Fire Station 21 – Greenwood
University Link, UW Station and Pedestrian Bridge

4 September 2008**Light Rail Review Panel Review**

Project: University Link, UW Station and Pedestrian Bridge
Phase: 60 Percent
Last Reviews: August 16, 2007, September 20, 2007, December 6, 2007
Presenters: Leo Berk, Artist
 Ron Endlich, Sound Transit
 Howard Fitzpatrick, Architect, LMN Architects
 Barb Luecke, Arts Coordinator, Sound Transit
 Barbara Swift, Landscape Architect, Swift Company

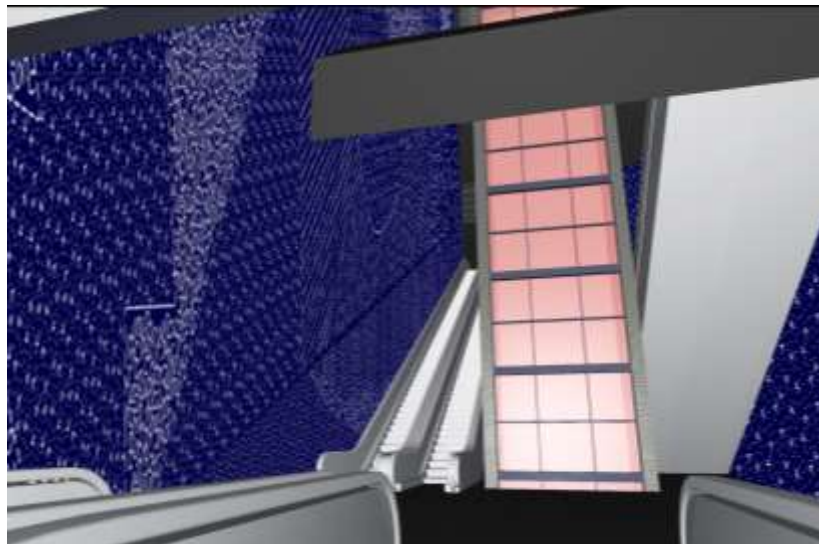
The chamber ceiling doesn't meet the lower mezzanine level; is that a functional need?

Some concerns about balancing contemplative experience of dappled lighting, with safety lighting.

The proposed design is to have the chamber form to read as a sculptural object in the space, and to complete itself before it hits the ceiling.

There is a challenge to keep panel system backlit, while maintaining required light levels.

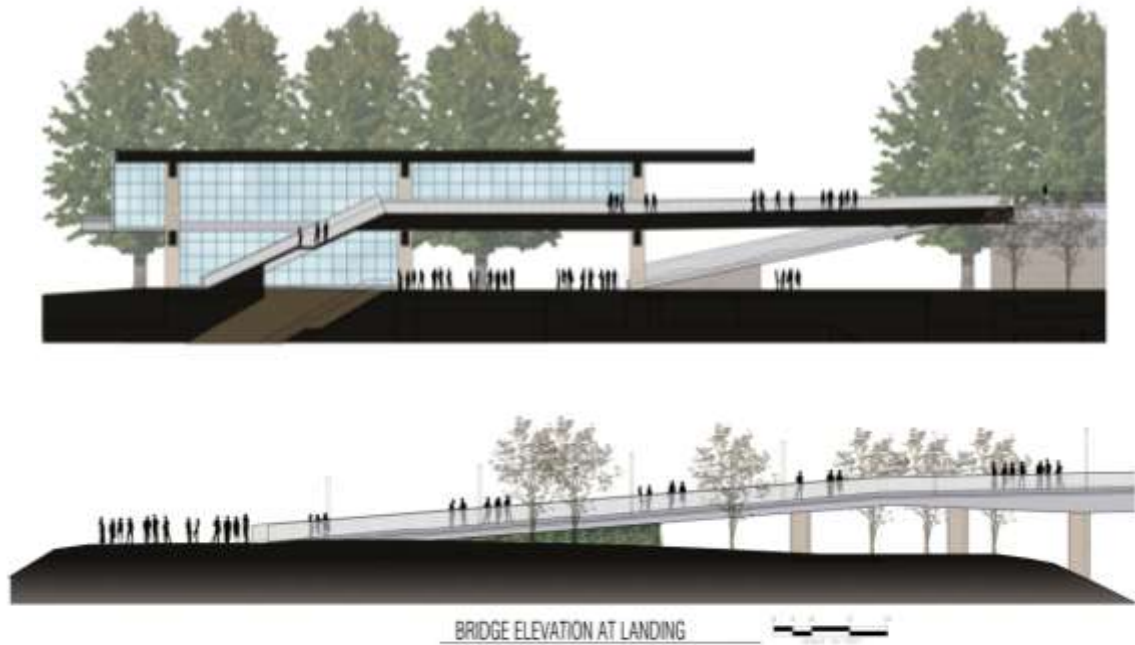
Is the head house glass clear, reflective, or colored?

What will the head house look like at night?

It is clear glass. We're working with the standard glazing system approved by Sound Transit.

It is illuminated from the ceiling, and will glow from within; although it is not designed to throw light outdoors.
